16-04-011BUG

Generator

Applicability:
Bugatti Veyron

Introduction:
Corrosion of the B+ Cable and connection to the generator.

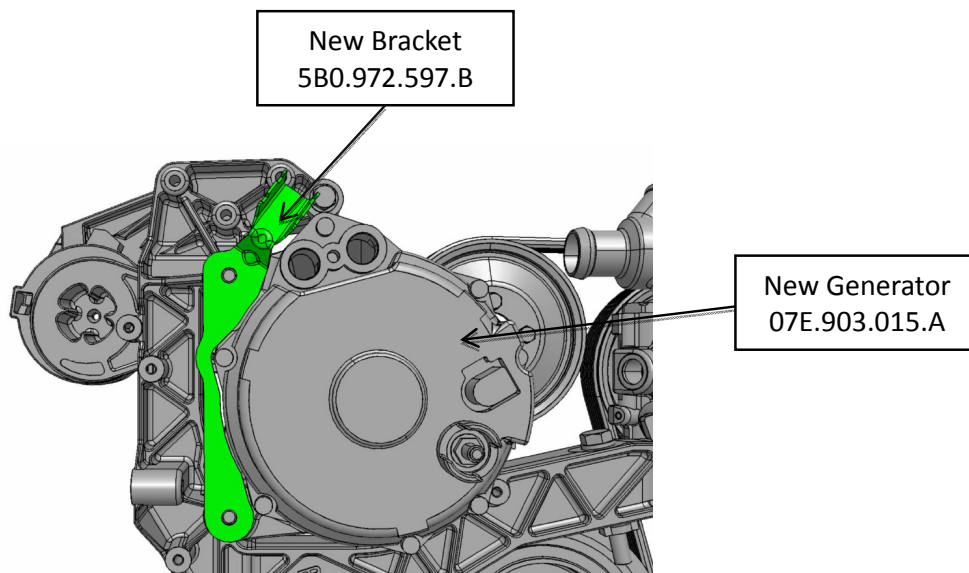
Description:
In extreme conditions, cable protection could be damaged.
Installation of latest level generator and improved B+ cable to avoid water ingress and therefore remove the risk of corrosion.

The main parts requiring replacement: *Generator / Generator wiring Harness B+ / Bracket.*

Designation	Old Part Number	New Part Number
Generator	07E.903.015	07E.903.015.A
Generator wiring harness	5B0.971.349	5B0.971.349.B
Generator bracket	5B0.972.597	5B0.972.597.B
Screw M8x95x80	N.906.602.02	N.911.607.01
Screw M8x115x80	N.906.602.02	N.911.608.01
Nut M8		N.901.838.02

The generator fixing screws must be replaced with the longer type. Please refer to table above.
